Re: Penrose Pit, Permit No. M-1987-131; Preliminary Adequacy Review for 112 Construction Materials Reclamation Permit Amendment Application (AM-03)

The Division of Reclamation, Mining and Safety (DRMS) has completed its preliminary adequacy review of your 112 Construction Materials Reclamation Permit Amendment Application (AM-03) for the Penrose Pit, Permit No. M-1987-131. The application was received on January 14, 2021 and after receiving corrections, called complete for review on January 29, 2021. **The decision date for this application is April 29, 2021.** Please be advised that if you are unable to satisfactorily address any concerns identified in this review before the decision date, **it will be your responsibility to request an extension of the review period.** If there are outstanding issues that have not been adequately addressed prior to the end of the review period, and no extension has been requested, the DRMS may deny this application.

Figure 1. Penrose Pit Affected Area Inconsistencies

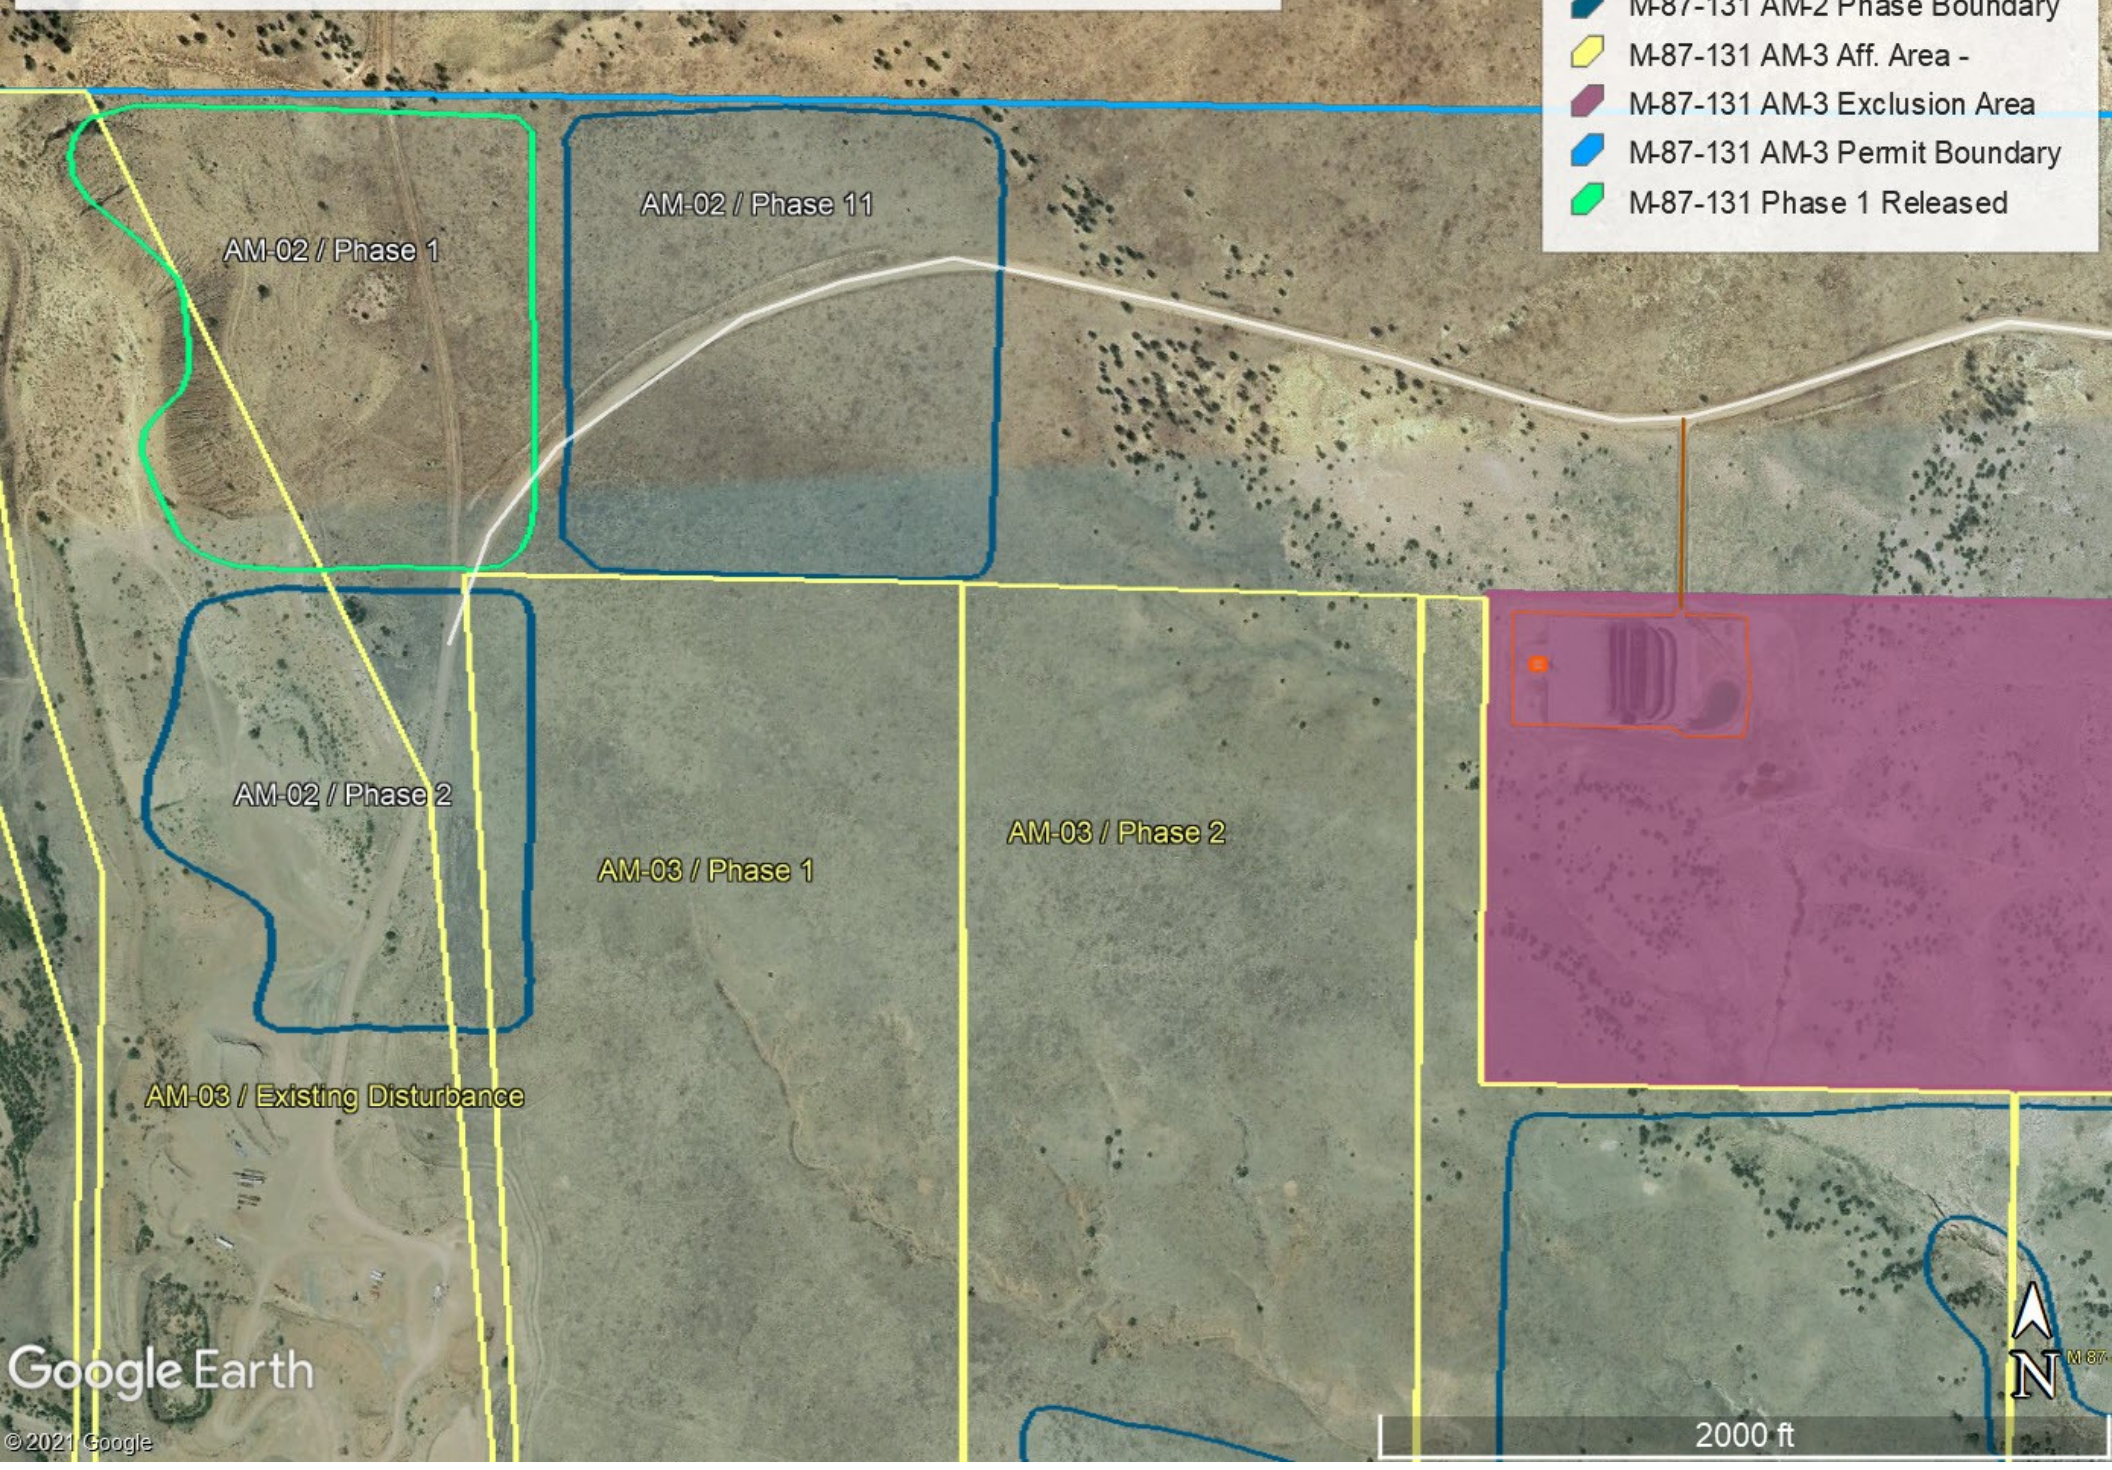
- i. The DRMS released Amendment 2 (AM-02) Phase 1 with the approval of acreage release request AR-01 in May 2020. As such, this is no longer part of the permit affected area. Portions of the AM-02 Phase 1 overlap what is

designated as “Current Affected Area” on the Penrose Pit Phase Map (please see attached **Figure 1** for reference).

- ii. The only way to release affected area from the permit without releasing the entire permit, is through an acre reduction request. Portions of AM-02 Phase 2 and all of AM-02 Phase 11 are no longer shown as affected area on the AM-03 Penrose Pit Phase Map (please see attached **Figure 1** for reference). If Fremont Paving wishes to remove these areas from the permit, a separate, but parallel request for acreage release will need to be processed.

Please submit a revised Exhibit C map to address these five issues. *(Note: the DRMS encourages Operators to have permit and affected area boundaries coincident unless there is an important reason not to do so.)*

Figure 2. Penrose Pit Affected Area Challenges

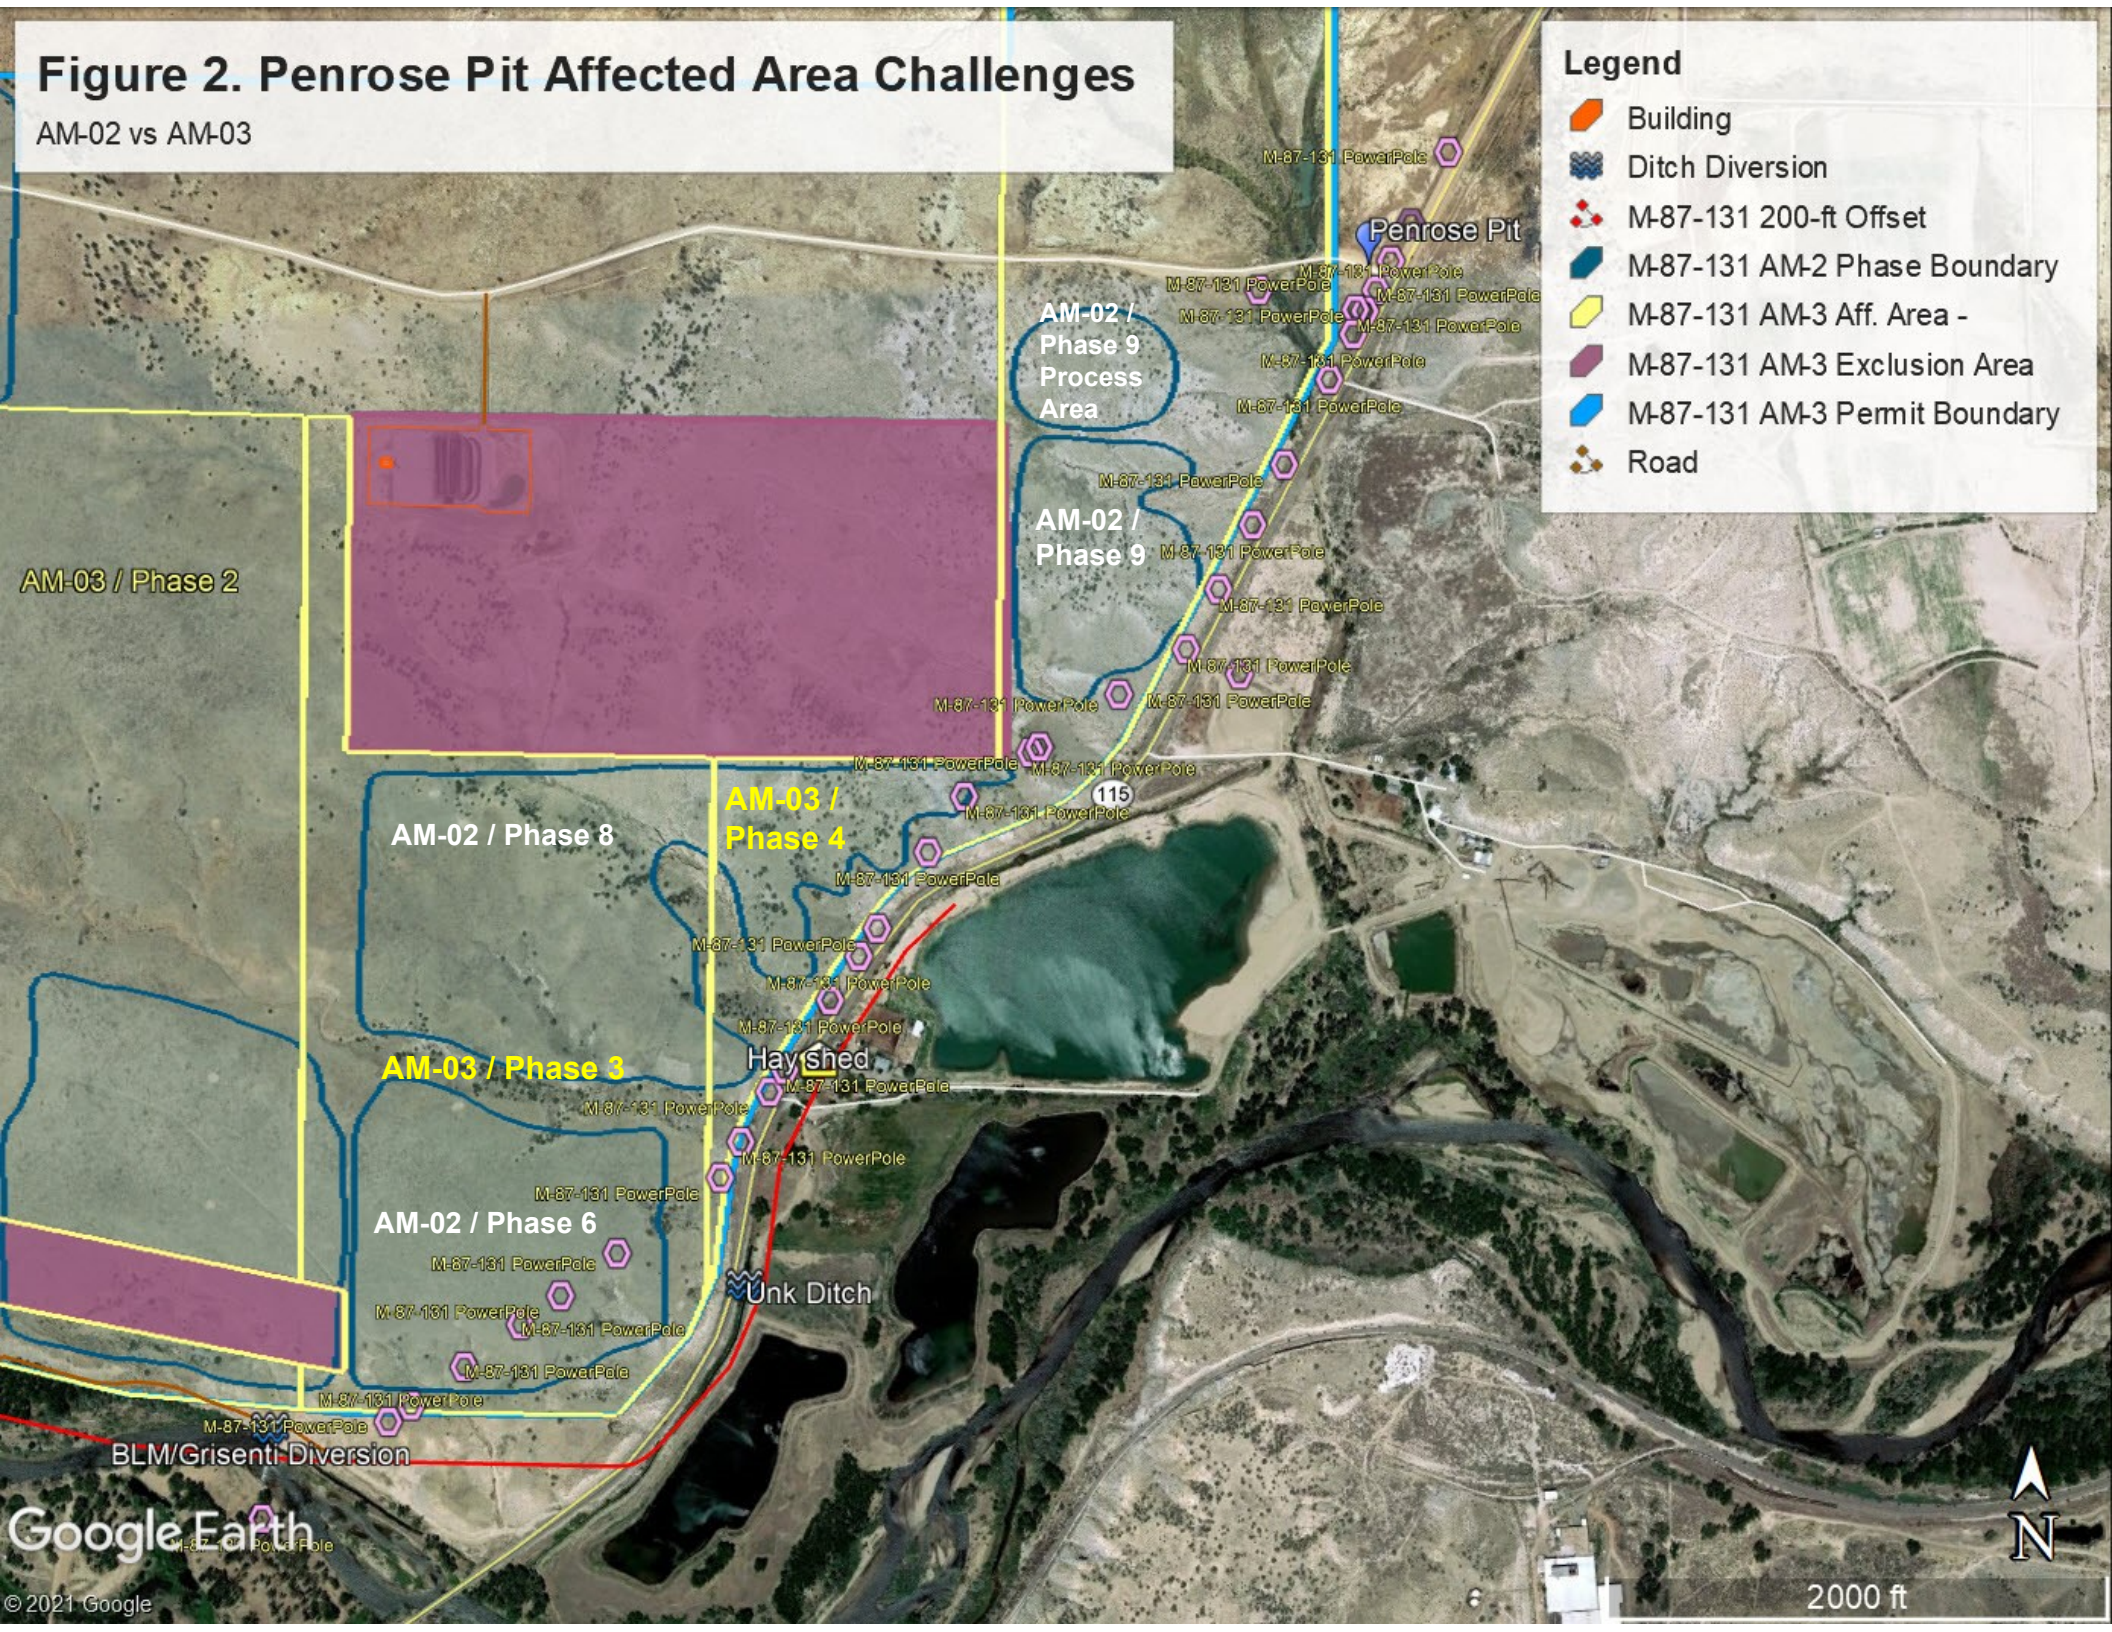
- iii. The powerline discussed in Exhibit S runs through or within 200 feet of AM-02’s Phases 6, 8 and 9 (please see attached **Figure 2** for reference). Assuming Exhibit S is correct, portions of AM-02’s phases 6, 8 and 9 will need to be released through a separate, but parallel acreage release request, as well as having to re-delineate AM-03 Phases 3 and 4.

- e. Rule 6.4.3(e) requires the type of present vegetation covering the affected lands be shown. No vegetation information is presented on any maps. A satellite image such as that presented as Exhibit B with notes on the drawing consistent with information presented in Exhibit J would be acceptable, or sometimes soil survey maps can be generated showing this information. Please provide an Exhibit C map with the required vegetation information.
- f. Rule 6.4.3(f) requires water resources information be presented in conjunction with Exhibit G. None of this information is presented in Exhibit C maps. Most of the required information is shown on one or the other of the two maps shown in Exhibit S (wells and ditches on the Penrose Pit map and the Arkansas River and Eightmile Creek on the Penrose Pit Land Owner Map). Not shown on either map is the

BLM/Grisenti diversion ditch (please see attached **Figure 2** for reference). Please include this information on an Exhibit C map, or reference where it can be found elsewhere in Exhibit C.
